Technical Service Bulletin: TSB190184

Water pump Boss conversion using Welding and Brazing processes

Water Pump Casting with Current Design Inbuild Arrangement of Pressure Sensor Mounting.
The current design of the pressure sensor mounting.

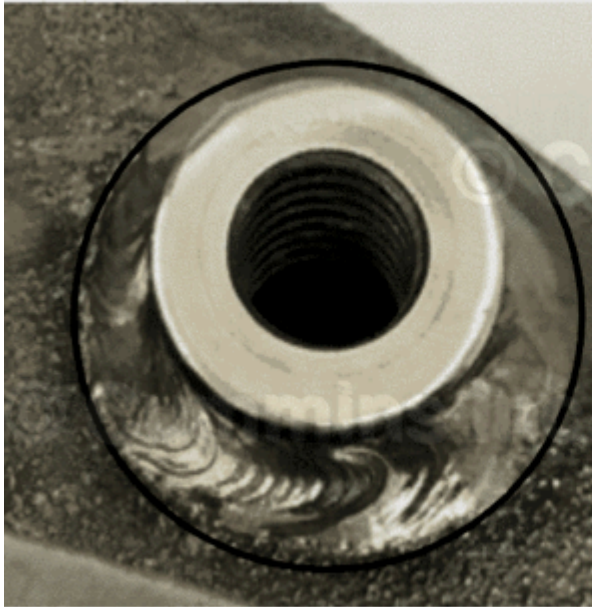
The recon process is converting old water pump bodies to new water pump bodies. The boss is introduced on old QSK water pump casting by using two processes: welding and brazing. Customer may receive new water pump bodies with boss as per new current design, or converted water pump bodies with boss using brazing and welding processes.

- The water pump designs on the following new model part numbers have arrangements of a boss for the mounting pressure sensor:
 - 4376118RX
 - 4376119RX
 - 4376120RX
 - 4376121RX
 - 4376122RX
- This boss for the mounting pressure sensor is **not** present in old water pump castings. The recon salvage process is converting old pump bodies by using either brazing and welding processes as current pump bodies and assembly for recon pumps.

No change to Part number(s), this TSB is to inform field that parts produced and sold using either brazing and welding processes may look visually different (see below for pictures), but have the same fit, form, and function.

Parts produced with old bodies using brazing and welding processes are completely compatible with same fit, form, and function. These parts are acceptable to use.
